Stage 3: Code Administrator Consultation		At what stage is this document in the process?										
<h1 style="color: #00a651;">GC0111:</h1> <h2 style="color: #00a651;">Mod Title: Fast Fault Current Injection specification text</h2>

GC0111 was proposed by Mike Kay on behalf of Electricity North West and was submitted to the Grid Code Review Panel in April 2018. The Panel decided to send the Proposal to a joint Workgroup (with the Distribution Code) to be developed and assessed against the Grid Code Applicable Objectives.

GC0111 aims to update the Grid Code with revised text for fast fault current injection to dispel any confusion in interpretation of the existing text.

Figure 15.0

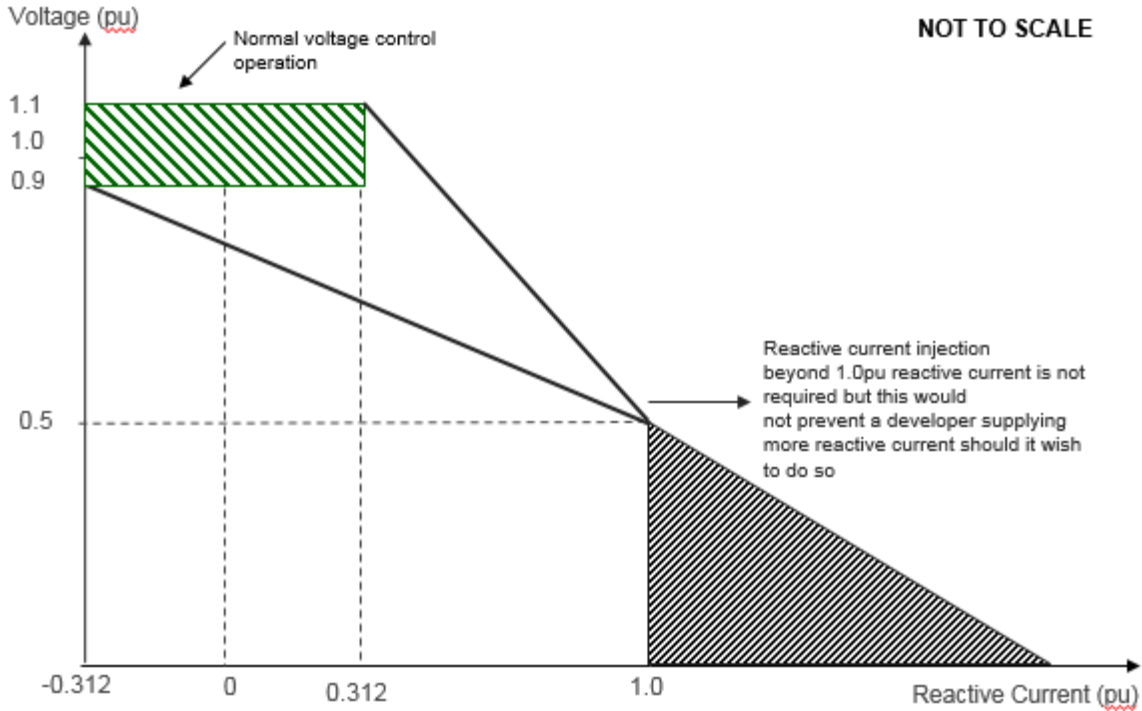
In this case, the point was raised that a plant could be operating at 0.9 power factor in a leading mode of operation at 0.9 pu voltage which could only apply in a power factor or reactive power mode of operation and even then in the unlikely event this were to occur, the voltage would have to drop for a small amount even to get zero injection of reactive current although there would be a delta change (i.e. the difference between the final reactive current injection and the pre-fault reactive current injection) in transiting from a fully leading power factor to unity.

To address this concern, two points were raised. The first, that irrespective of the operating point within the normal voltage operating range, the locus of  $I_R$  should converge to the 0.5pu voltage / 1.0pu reactive current coordinate so as not solely to give a minimum performance requirement. Secondly, some concern was expressed as to how this requirement would interface with Figures ECC.6.3.16(b) and ECC.6.3.16(c). A comment was also noted that the upper boundary would not be required.

Figure 16.0

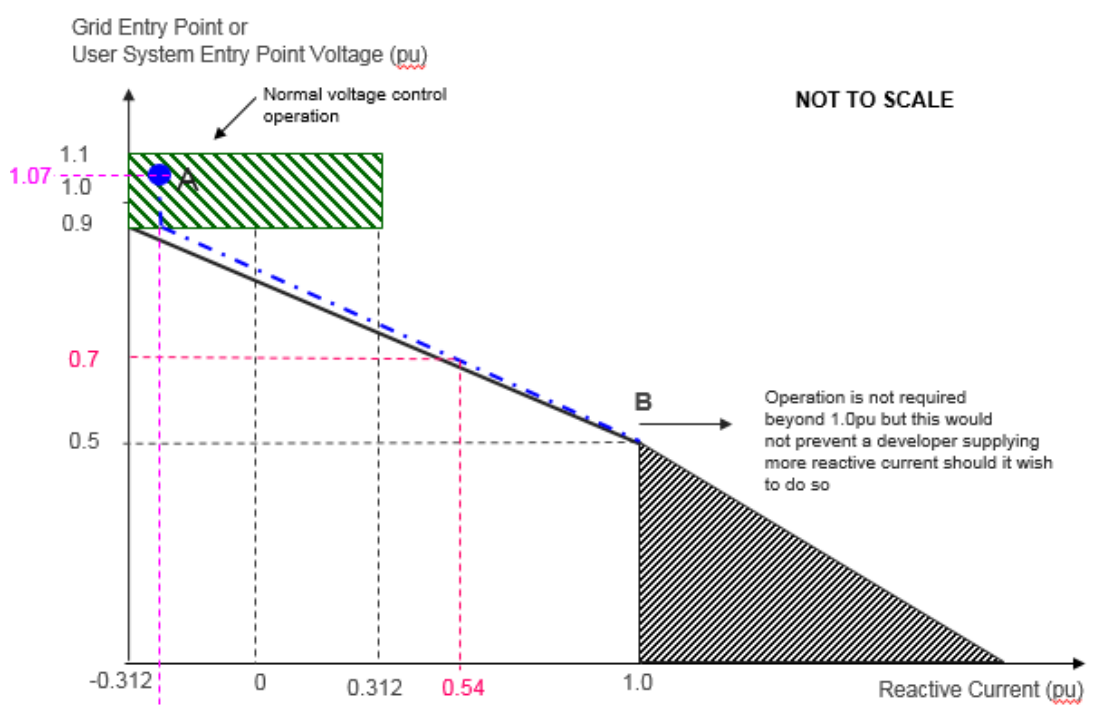
Figure 16 shows an illustrative requirement of the behaviour expected from a plant operating in the leading mode of operation and the  $I_R$  value required when subject to a voltage dip of 0.7pu at the connection point.

Figure ECC.6.3.16(a)

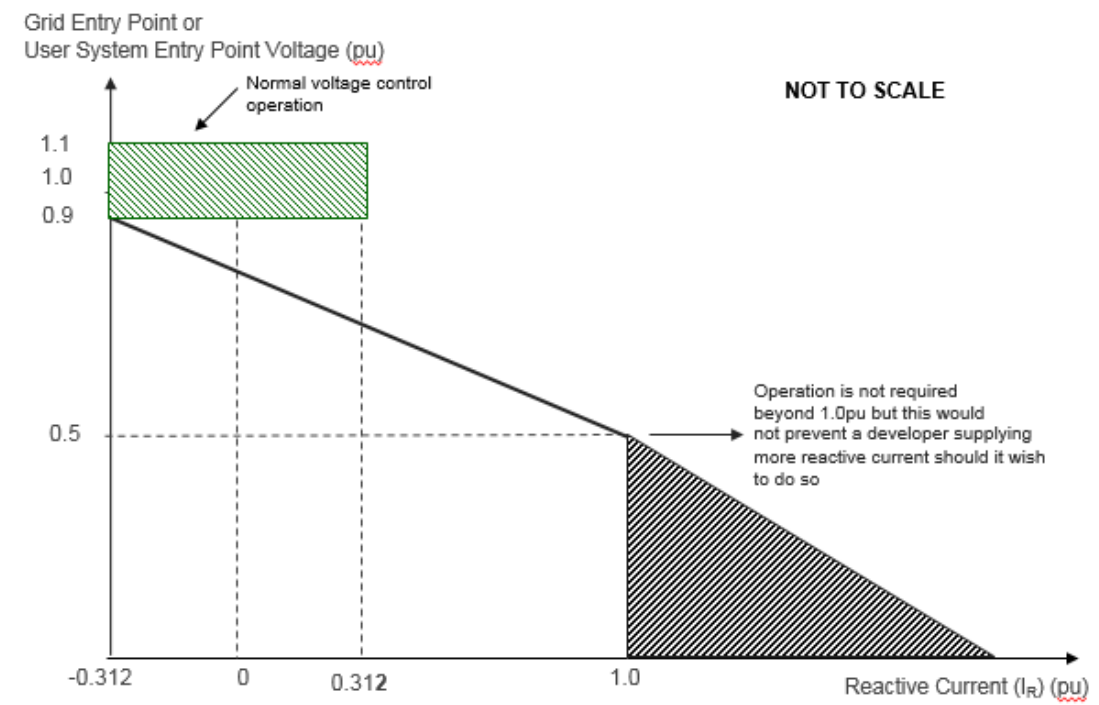
For any balanced ~~or unbalanced~~ fault which results in the positive phase sequence -voltage falling below the voltage levels specified in ECC.6.1.4 phase voltage on one or more phases falling outside the limits specified in ECC.6.1.2 at the **Grid Entry Point** or **User System Entry Point (if Embedded)**, each **Type B, Type C and Type D Power Park Module** or each Power Park Unit within a Type B, Type C and Type D Power Park Module or HVDC Equipment shall, as a minimum (unless an alternative type registered solution has unless otherwise been agreed with The Company), be required to inject a reactive current above the ~~heavy black line shaded area~~ shown in Figure ECC.16.3.16(a) and Figure 16.3.16(b). For the purposes of this requirement, the maximum rated current is taken to be the maximum current each Power Park Module (or constituent **Power Park Unit**) or **HVDC Converter** is capable of supplying when operating at rated **Active Power** and rated **Reactive Power** (as required under ECC.6.3.2) at a nominal voltage of 1.0pu. For example, in the case of a 100MW **Power Park Module** the **Rated Active Power** would be taken as 100MW and the rated **Reactive Power** would be taken as 32.8MVARs (ie **Rated MW** output operating at 0.95 **Power Factor** lead or 0.95 **Power Factor** lag as required under ECC.6.3.2.4). For the avoidance of doubt, where the phase voltage at the **Grid Entry Point** or **User System Entry Point** is not zero, the reactive current injected shall be in proportion to the retained voltage at the **Grid Entry Point** or **User System Entry Point** but shall still be required to remain above the shaded area in Figure 16.3.16(a) and Figure 16.3.16(b).

ECC.6.3.16.1.3 Figure ECC.6.3.16(a) defines the reactive current ( $I_R$ ) to be supplied under a faulted condition which shall be dependent upon the pre-fault operating condition and the retained voltage at the **Grid Entry Point** or **User System Entry Point** voltage. For the avoidance of doubt, each **Power Park Module** (and any constituent element thereof) or **HVDC Equipment**, shall be required to inject a reactive current ( $I_R$ ) which shall be not less than its pre-fault reactive current and which shall as a minimum increase with the fall in the retained voltage each time the retained-voltage at the **Grid Entry Point** or **User System Entry Point (if Embedded)** falls below 0.9pu whilst ensuring the overall rating of the **Power Park Module** (or constituent element thereof) or **HVDC Equipment** shall not be exceeded.
